MEMORANDUM

TO: Nick Senn
FROM: Mike Fowler
DATE: December 21, 2021
RE: **27th Street Underpass – Plan Revisions under Advertisement**

The plans listed below are hereby revised under advertisement due to the elimination of retaining walls 1 and 3 and some minor quantity changes. The boulder walls have been eliminated from the project and the slopes in these areas regraded. The revised plan sheets are attached and a revised Bid Schedule has been provided via email.

27TH ST AND SH82 PEDESTRIAN UNDERPASS TYPICAL SECTIONS (1)			
Engineer:	MDF	Structure Numbers	
Drawn By:	AMC	Subset Sheets:	1 of 2
Sheet Subset:	TYP

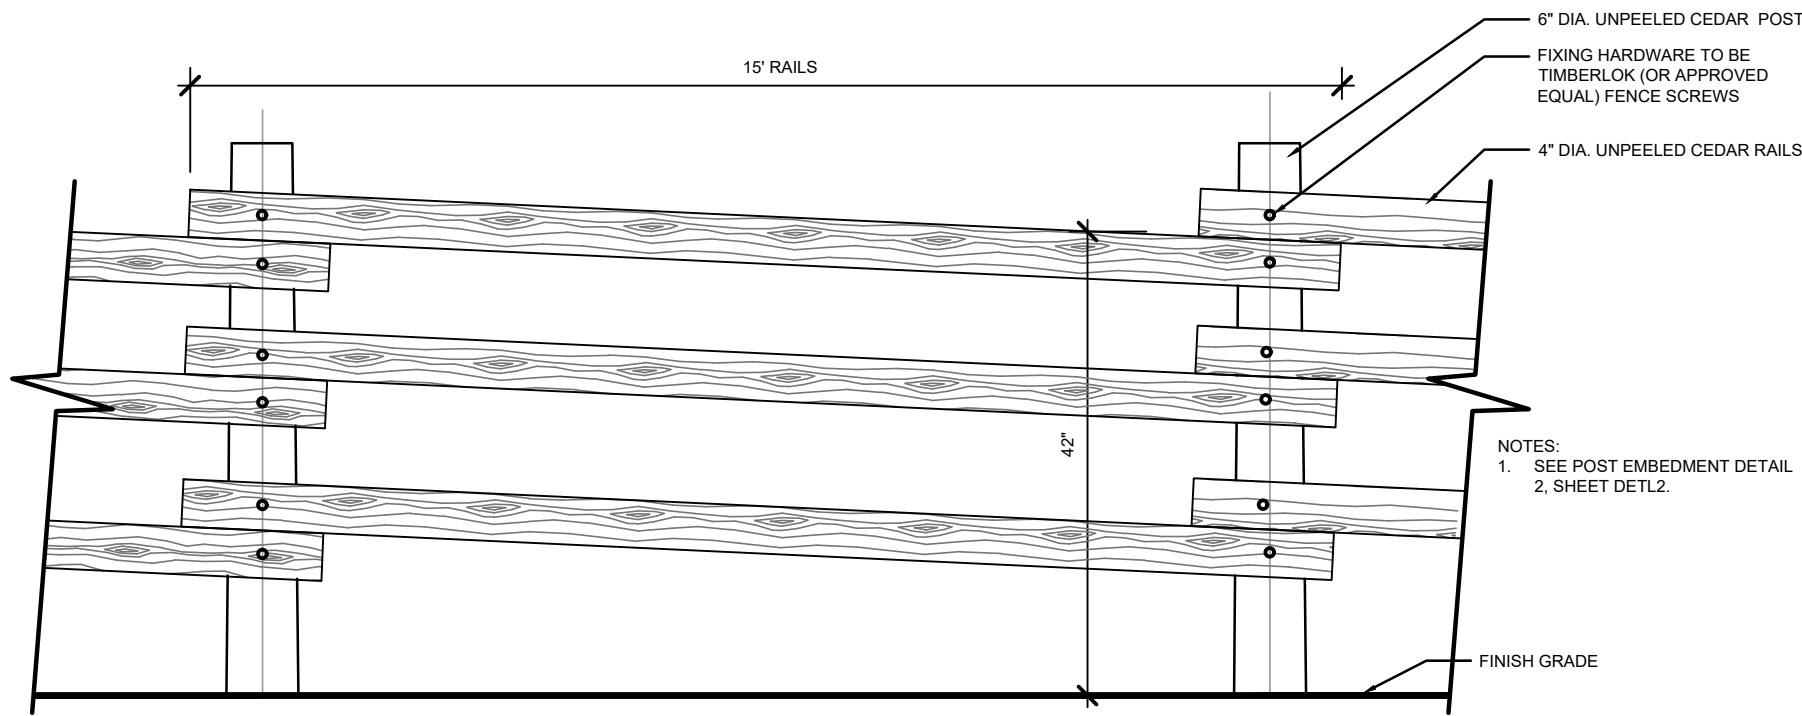
Sheet Revisions			
Rev.	Date	Comments	Init.
1	12/22/21	ELIMINATED WALLS 1&3	MWM

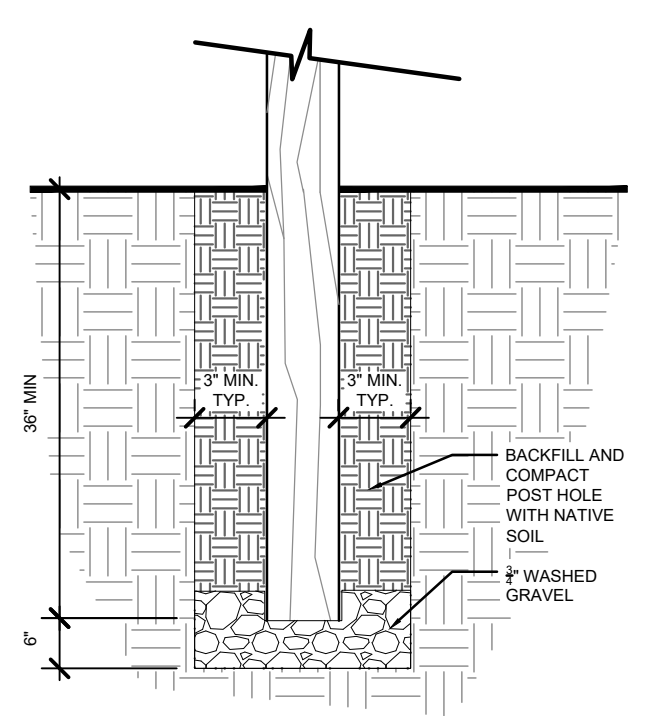
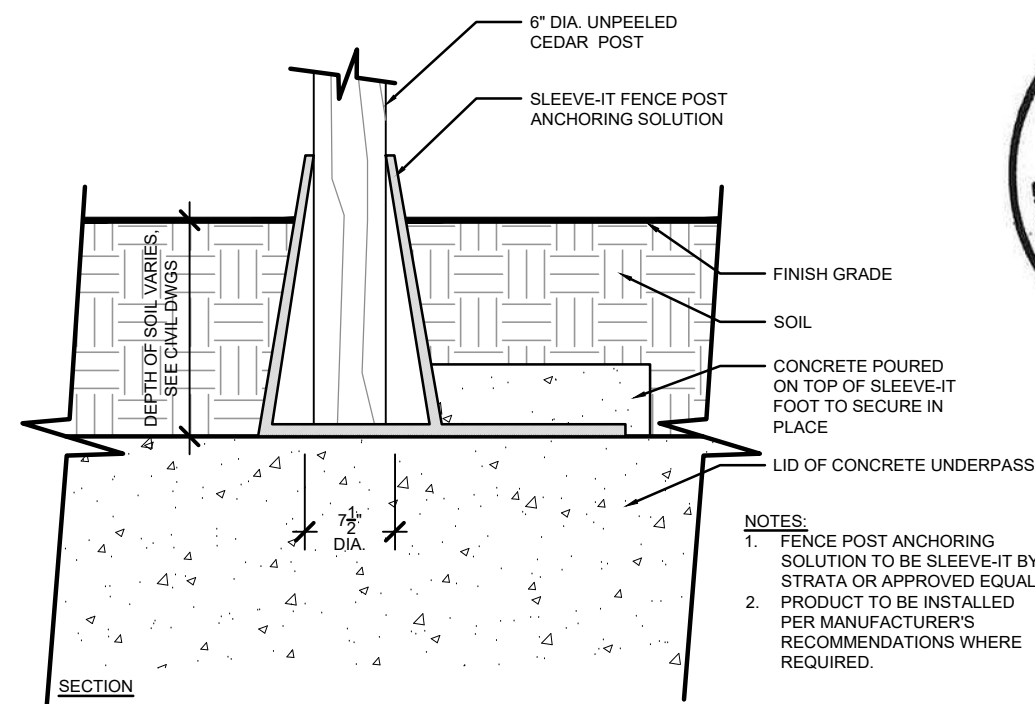
Computer File Information		Sheet Revisions			As Constructed	27TH ST AND SH82 PEDESTRIAN UNDERPASS		Project No./Code
FENCE AND RAILING DETAILS		Rev.	Date	Comments		Structure Numbers		
Print Date:	12/20/21	1	12.22.21	ELIMINATED WALLS 1 & 3	No Revisions:	Designer:	JJ	Code: 23687 / 23975
Last Modification Date:	12/22/21				Revised:	Drawn By:	DB	Sheet Number
Drawing File Name:	UNDERPASS_L-3-0_DETAILS rev numbers				Void:	Sheet Subset:	DETAILS	2 of 8
Autocad Ver.	2020 Scale: As Shown					Subset Sheets:		9
SGM Project No.:	2020-544.001							
	Quality Control: XX

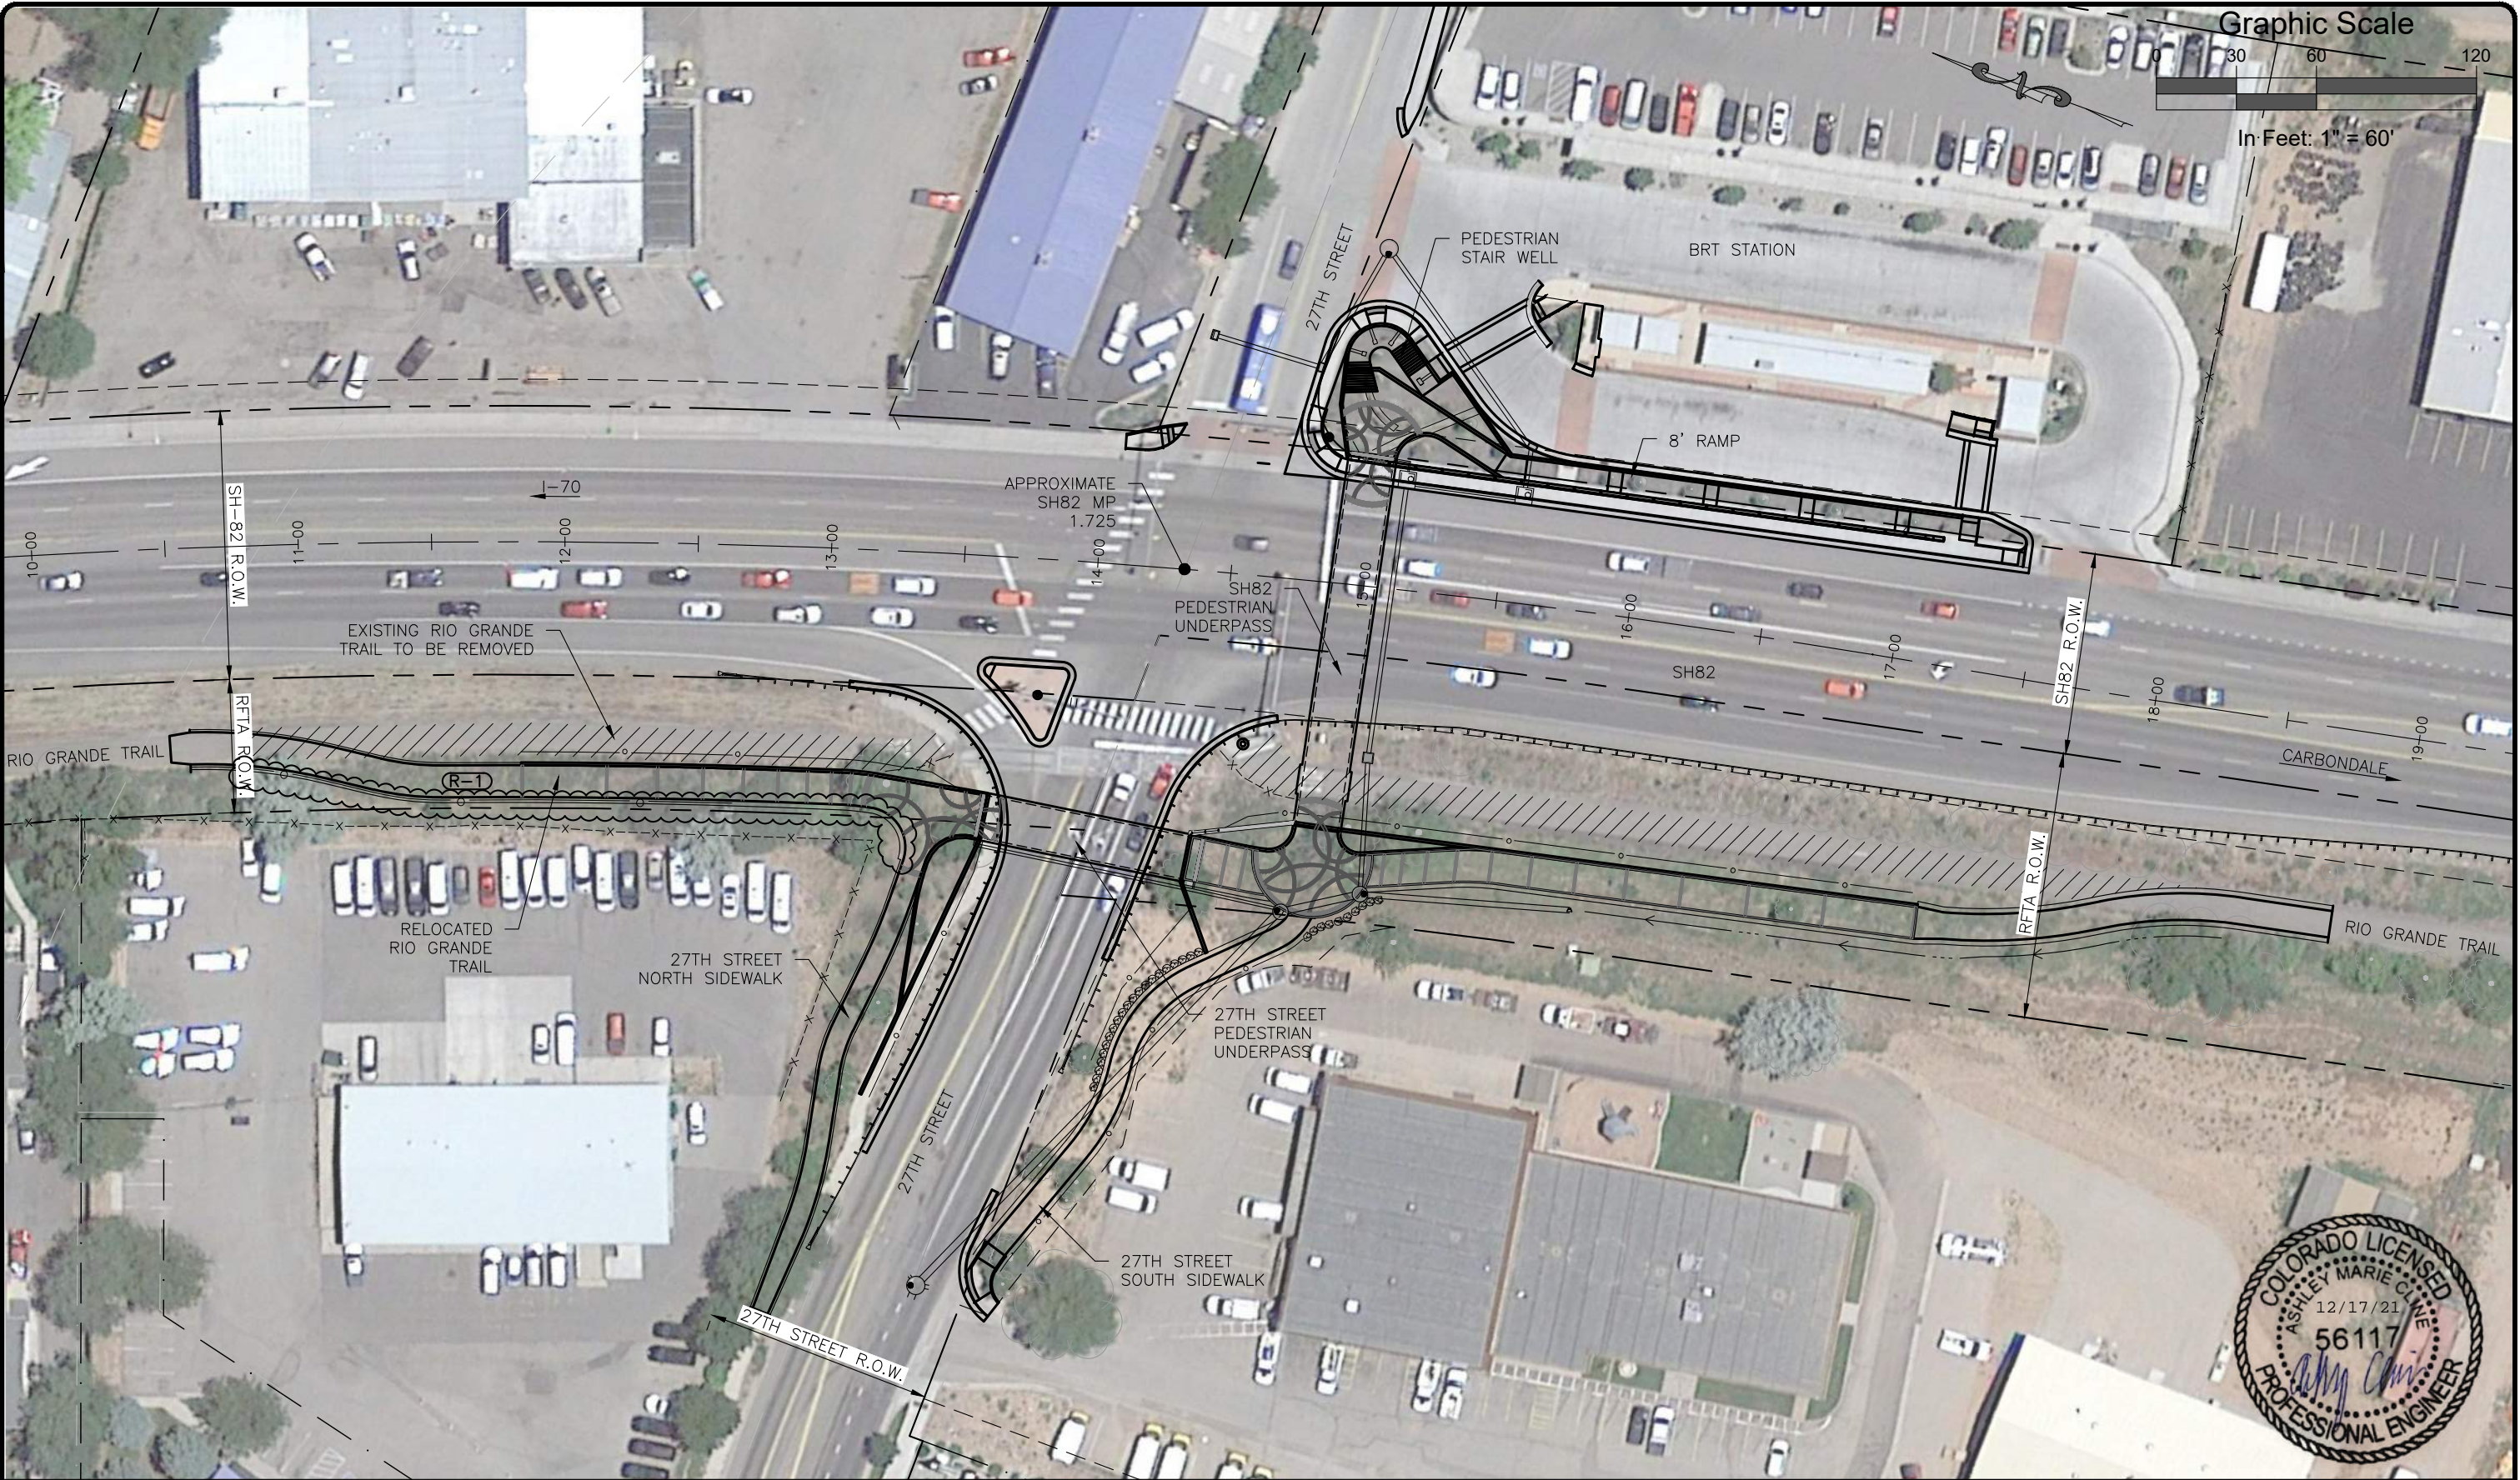
Rev.	Date	Comments	Init.	1	12/22/21	ELIMINATED WALLS 1&3	MWM									  <p>118 West Sixth Street, Suite 200 Glenwood Springs, CO 81601 970.945.1004 www.sgm-inc.com</p>		As Constructed No Revisions: Revised: Void:		27TH ST AND SH82 PEDESTRIAN UNDERPASS OVERALL SITE PLAN Engineer: MDF Structure Numbers Drawn By: AMC Sheet Subset: SITE Subset Sheets: 1 of 2		Project No./Code MTF M535-007 / 008 23687 / 23975 Sheet Number 35	
Rev.	Date	Comments	Init.																								
1	12/22/21	ELIMINATED WALLS 1&3	MWM
